C3 Characterization of Source Term

KONISHI Koji
Nuclear Regulation Authority JAPAN

2nd IAEA Regulatory Review Mission on ALPS Treated Water Handling
17 January 2023

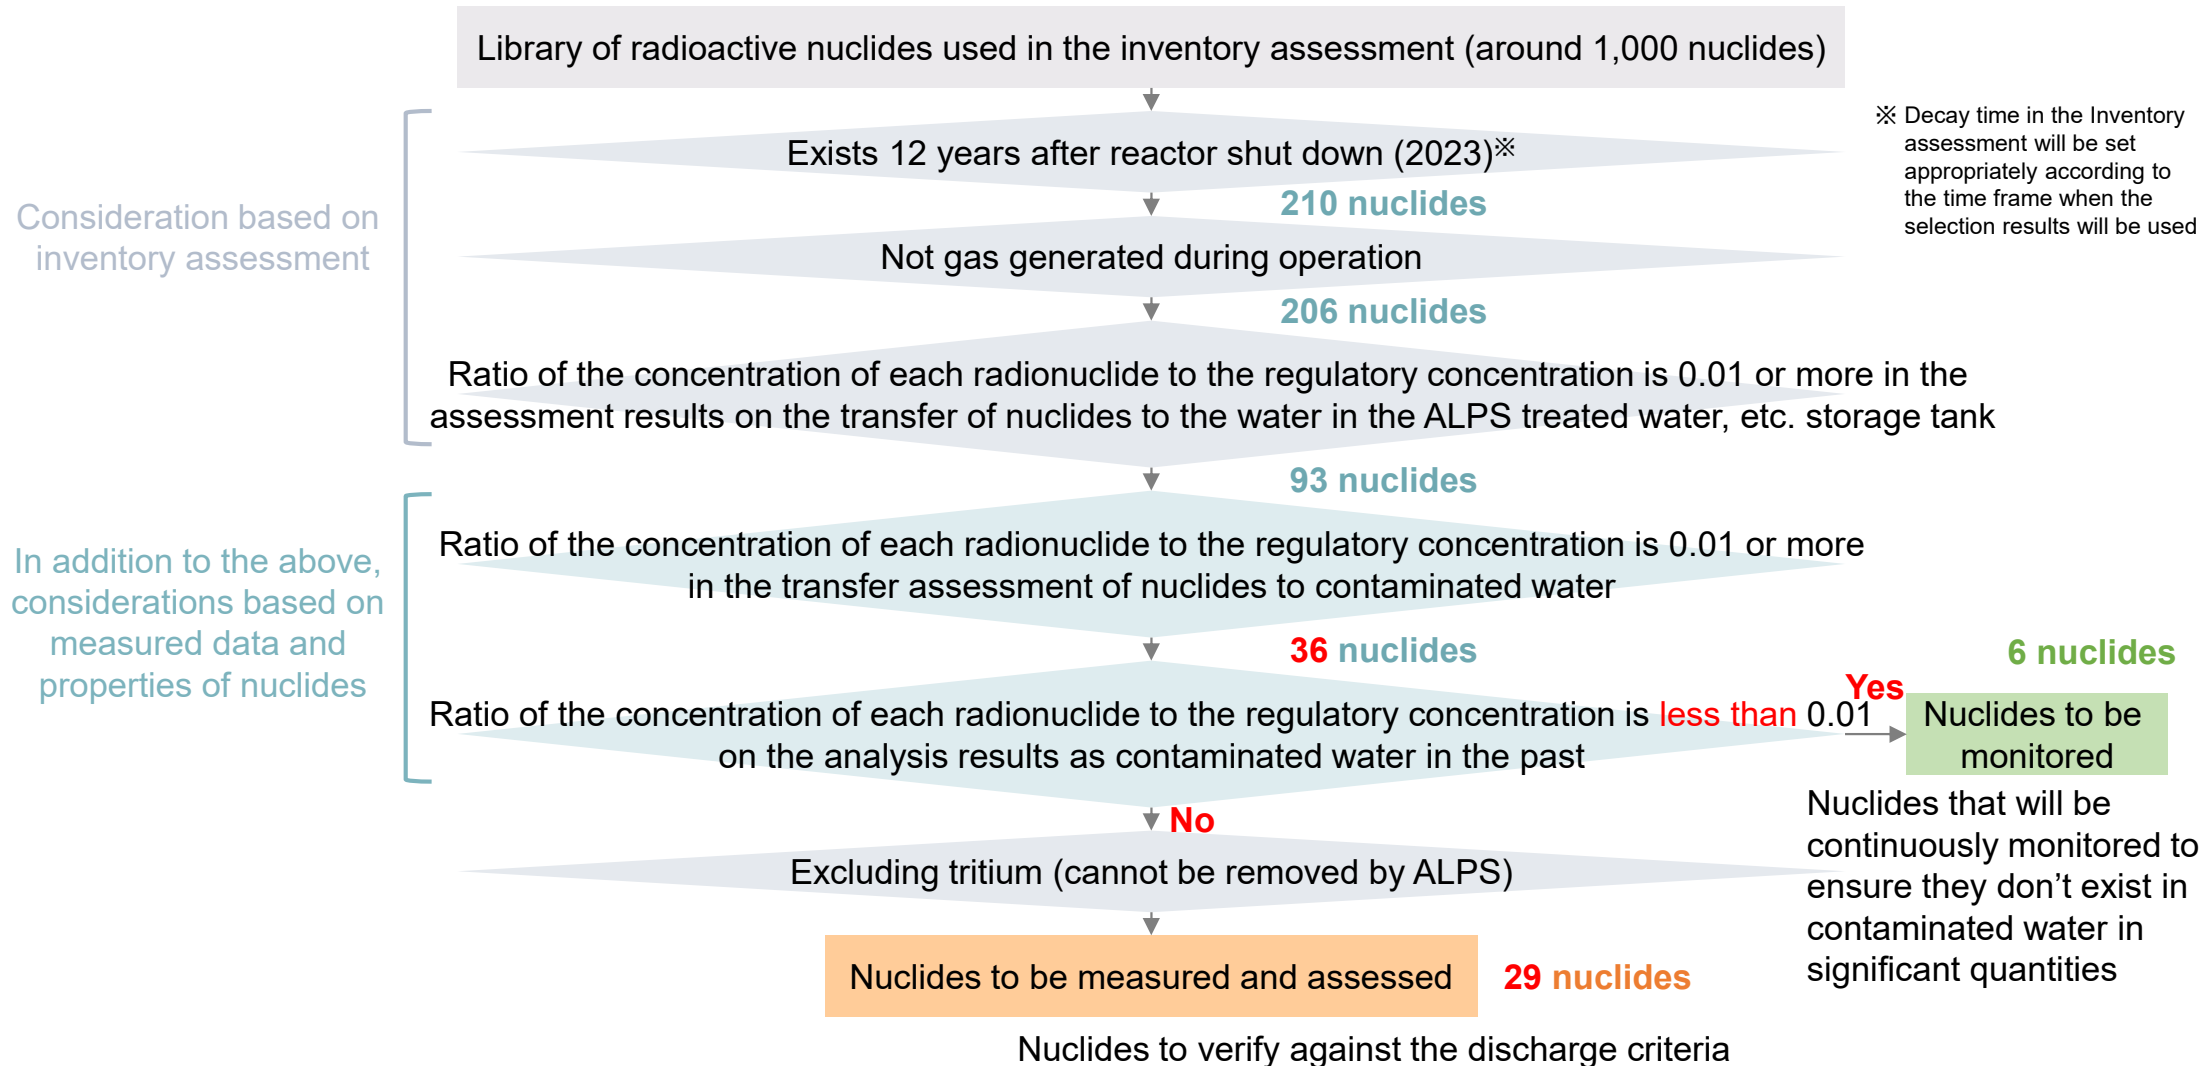
- Validity of categorizing nuclides into to be measured/assessed and to be monitored

⇒ Nuclides to be monitored is not excluded by step ④, due to the conservative condition at calculation of dissolve assessment. However, these nuclides never detected at the analysis of contaminated water, and these N.D. were less than 1/100 of regulatory concentration limit, therefore the possibility of existence are significantly low both in the current contaminated water transferred to treatment and ALPS treated water.

On the other hand, inventory of these nuclides are relatively large, and its half-life is long. Therefore, TEPCO will analyze Nuclides to be monitored once a year to ensure they don't exist in contaminated water in significant quantities, since these nuclides might be transferred into contaminated water due to the progress of decommissioning.

The NRA confirmed that categorizing nuclides at ⑤ is valid, and examined the validity of its criteria

Result of TEPCO's scheme

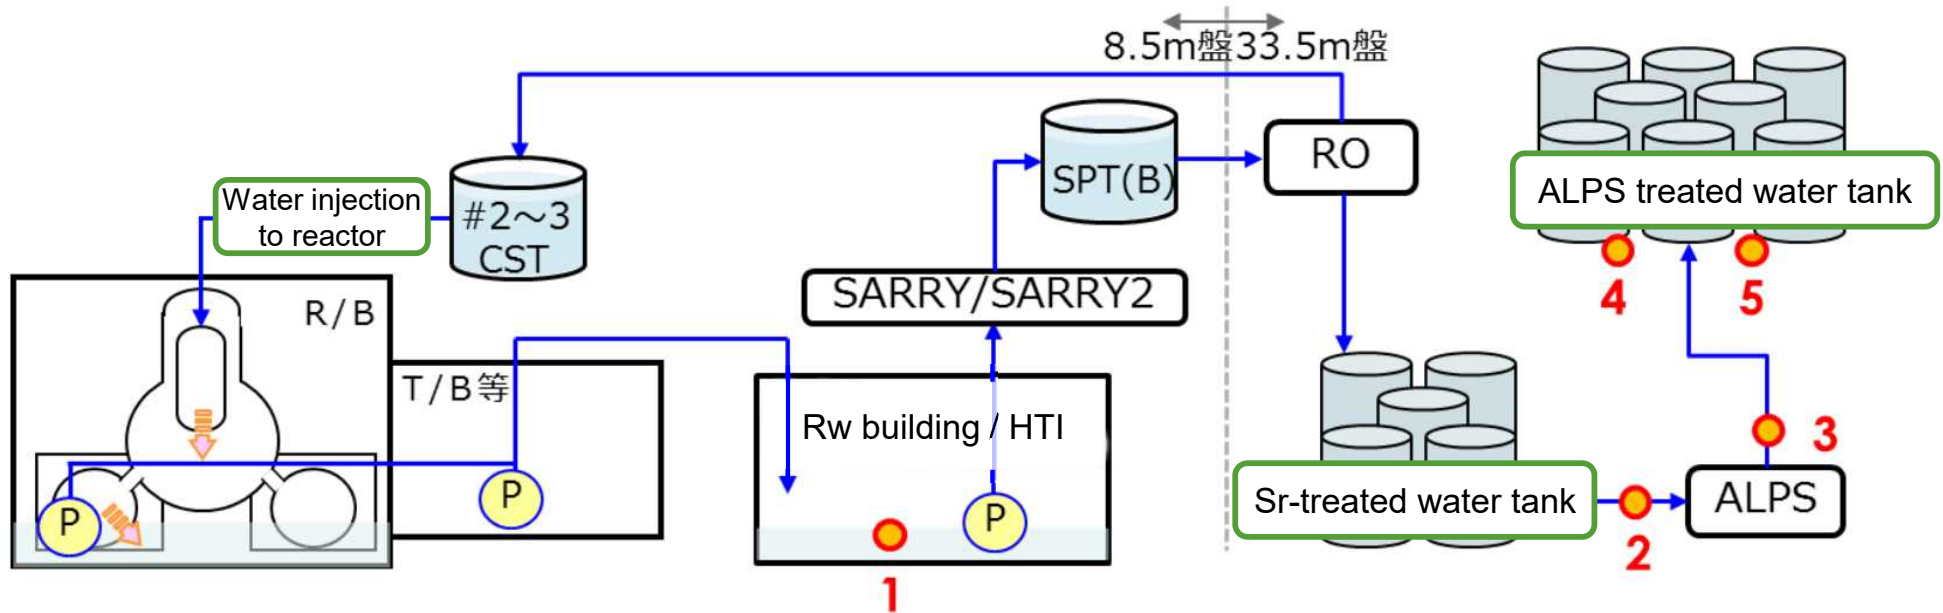
Nuclides which category changed from the submission of "Application"
